BID ADDENDUM NO. (2)

3/5/26

Prattsburgh Central School District
2025 Capital Improvements Project
2716-043

The following Addendum items shall be considered a part of the contract documents prepared by HUNT ENGINEERS, ARCHITECTS, LAND SURVEYORS & LANDSCAPE ARCHITECT, DPC. Bid Document date of (12/18/2025).

AD2-L2
 PROJECT NO: 2716-043

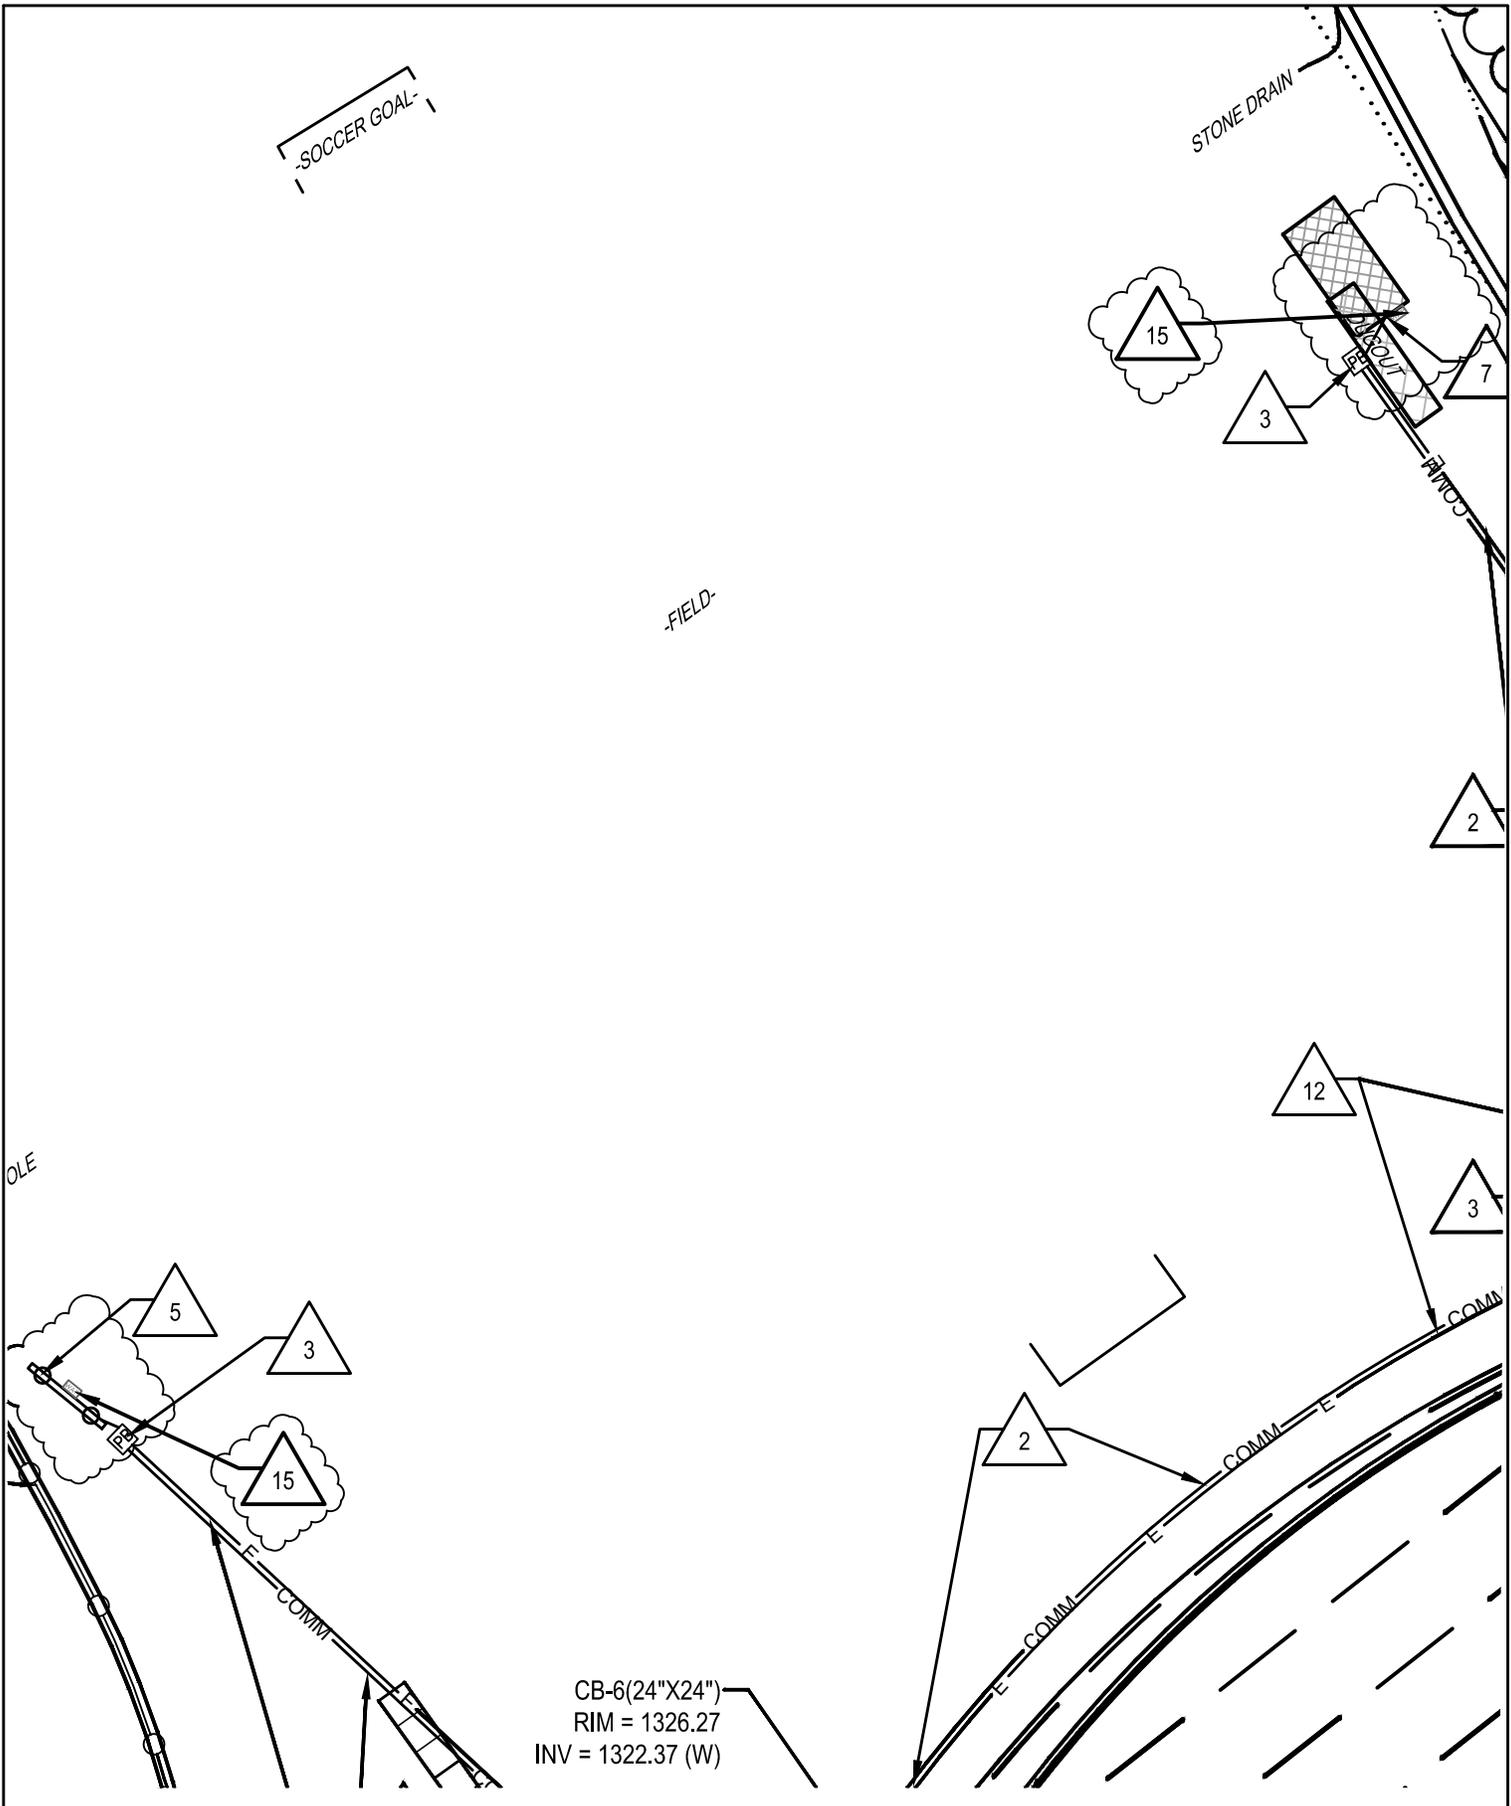
ITEM AD2-36 Refer to Drawing L5.2-SITE UTILITY PLAN

AMEND Detail 1 as shown on AD2-L2 SOFTBALL BACKSTOP UPDATE, issued by addendum.

AD2-L3
 DATE:
 03/04/26
 PROJECT NO:
 2716-043

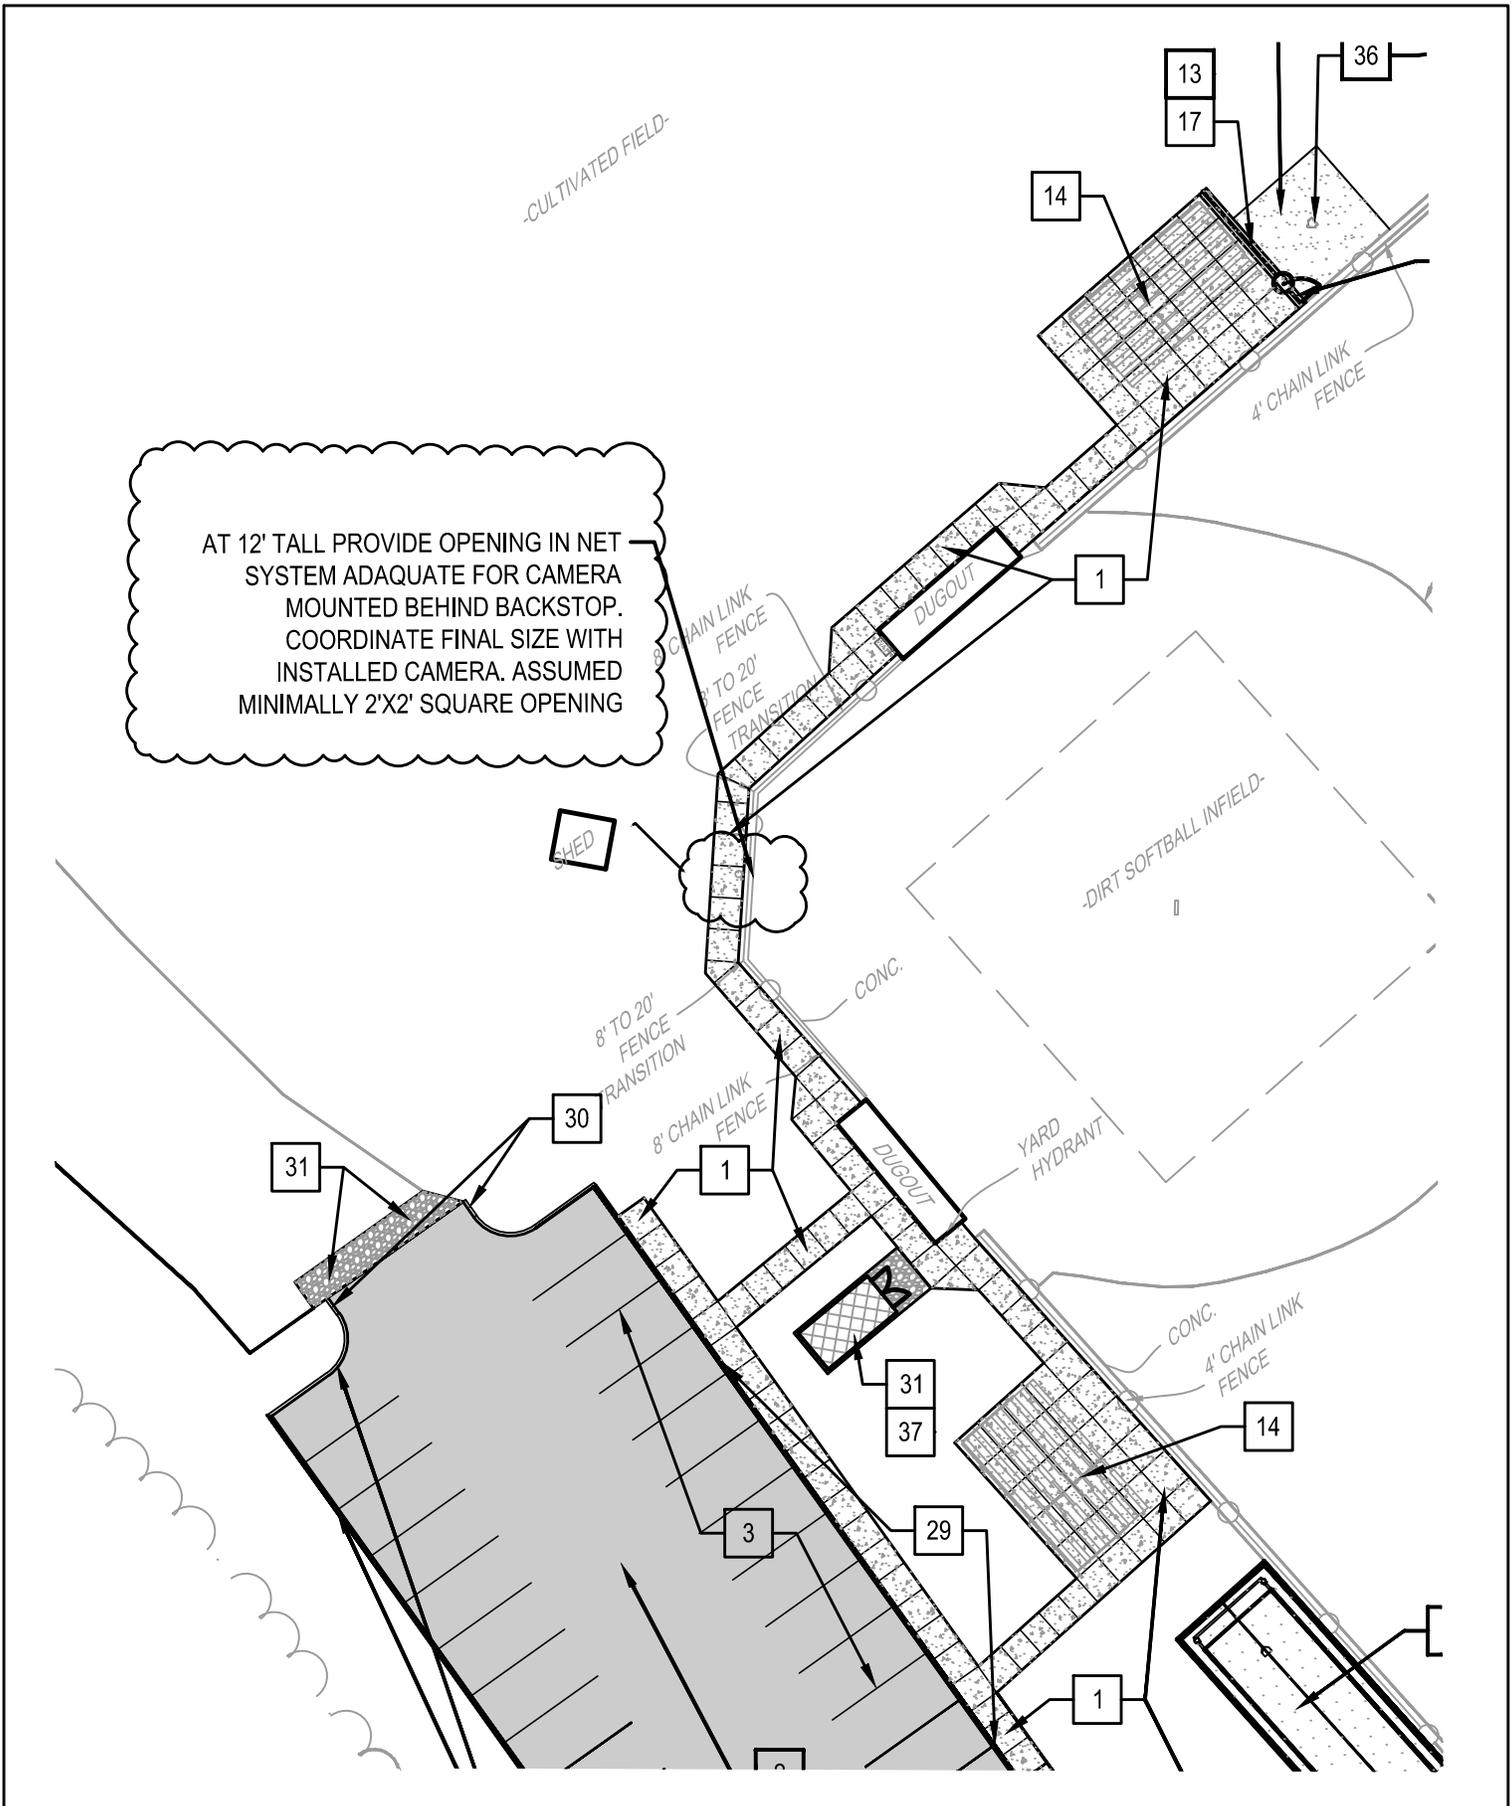
ITEM AD2-37 Refer to Drawing L5.2-SITE UTILITY PLAN

AMEND Detail 1 as shown on AD2-L3 WAP AT SOCCER FIELD AND SCOREBOARD UPDATE, issued by addendum.

AD2-A1

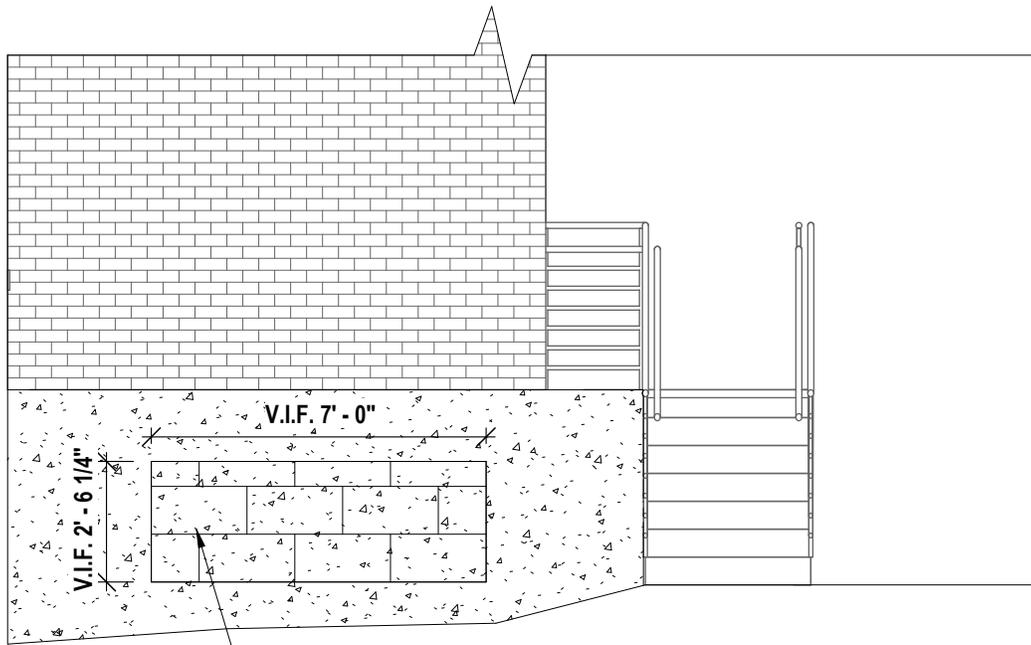
ITEM AD2-18 Refer to Drawing MB-A1.11 ROOF PLAN - AREA A

AMEND Detail #1 as shown on drawing AD2-A1 - ROOF DETAIL @ CANOPY EXTENSION - EXG. CANOPY, issued with this addendum.

AD2-A2

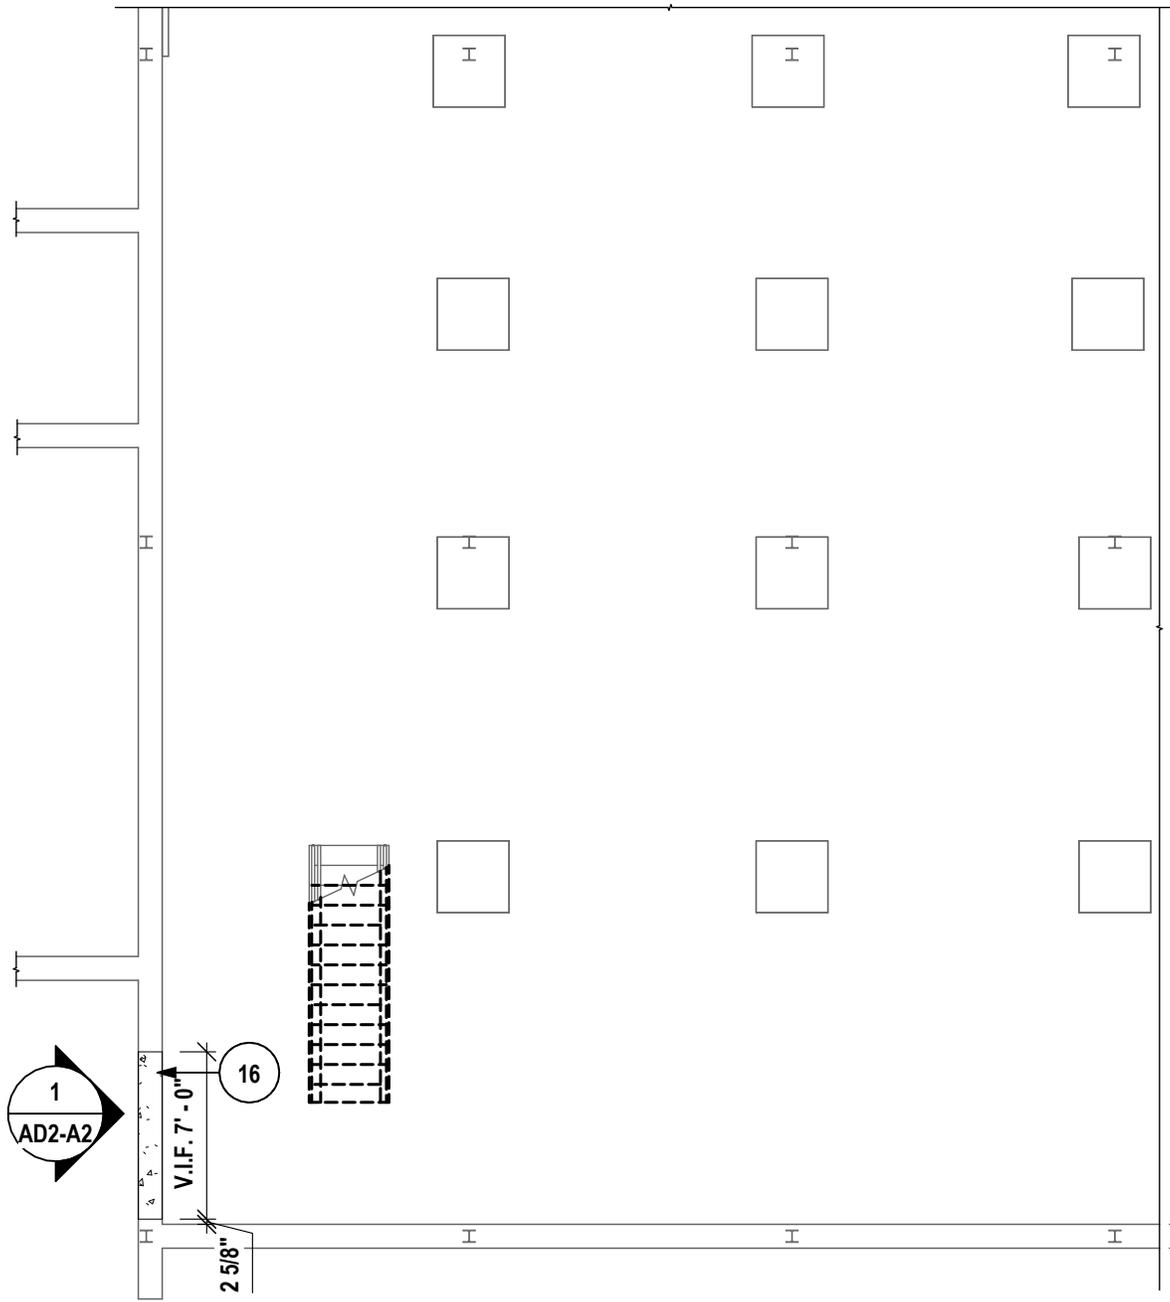
ITEM AD2-20 Refer to Drawing MB-A3.1 – EXTERIOR ELEVATIONS

AMEND Detail #1 as shown on drawing AD2-A2 – LOUVER INFILL @ EXTERIOR ELEVATION, issued with this addendum.

REMOVE EXISTING FOUNDATION HVAC LOUVER IN ITS ENTIRETY. REPAIR AND PREP EXISTING SURFACES FOR NEW WORK. INFILL FOUNDATION OPENING WITH 4" CMU AT PERIMETER WITH BACKERROD & CAULK INTERIOR SIDE OF CMU INFILL PROVIDE 4" OF POLYISO, HAT TRACK AND 5/8" GYPSUM INTERIOR FACE. TAPE AND PAINT INTERIOR GYP. "

1 CRAWLSPACE PLAN - AREA B
 1/8" = 1'-0"

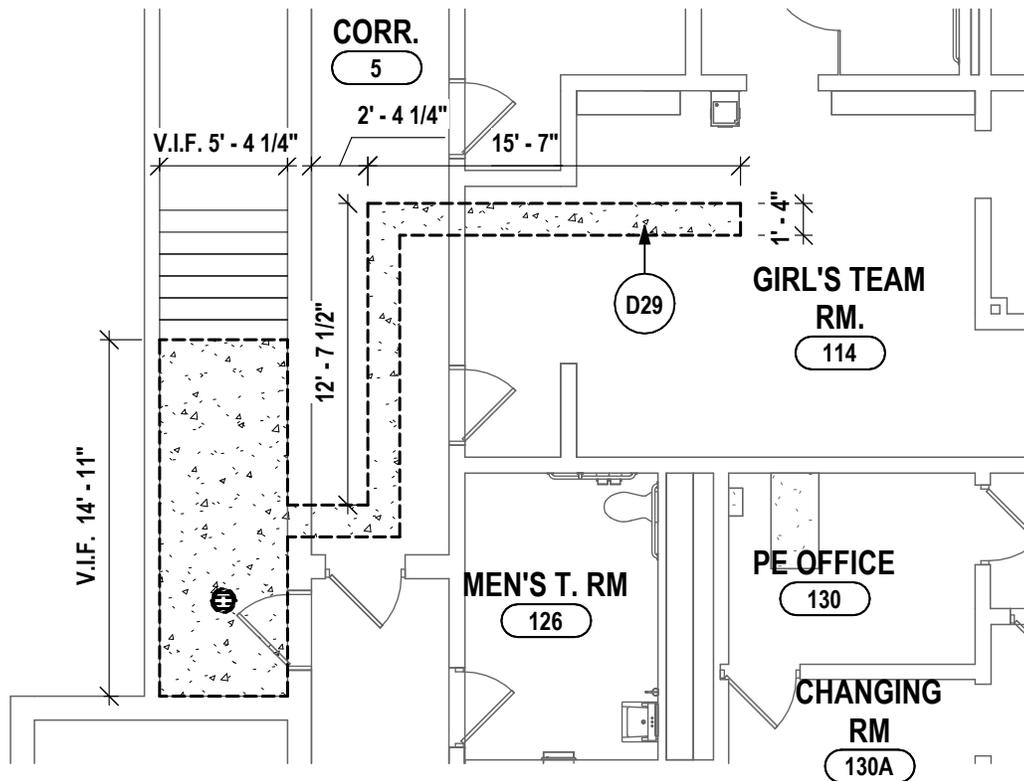
ITEM AD2-17 Refer to Drawing MB-A1.3 GROUND FLOOR PLAN – AREA A

AMEND Detail #1 as shown on drawing AD2-A3 – CRAWLSPACE PLAN – AREA B, issued with this addendum.

1 **GROUND FLOOR - AREA A TRENCHING @ FLOOR DRAIN**
 1/8" = 1'-0"

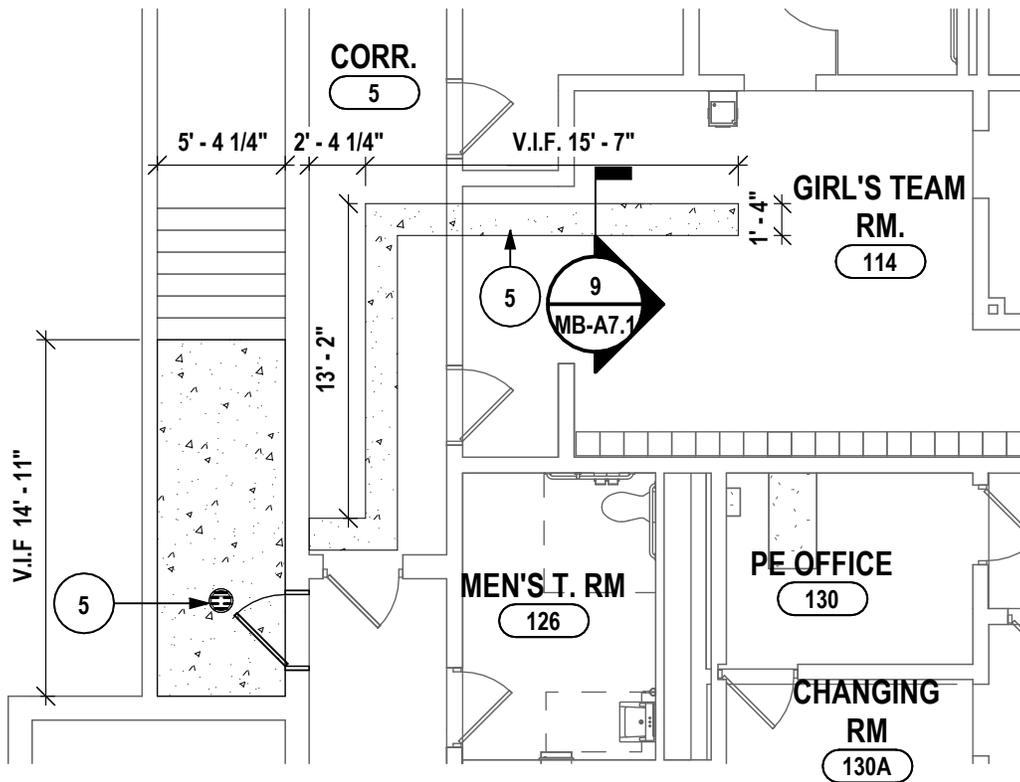
ITEM AD2-13 Refer to Drawings MB-A0.1 – GROUND FLOOR DEMO PLAN – AREA A

AMEND Detail 1 per drawing AD2-A4 – GROUND FLOOR AREA A TRENCHING @ FLOOR DRAIN as issued by this addendum.
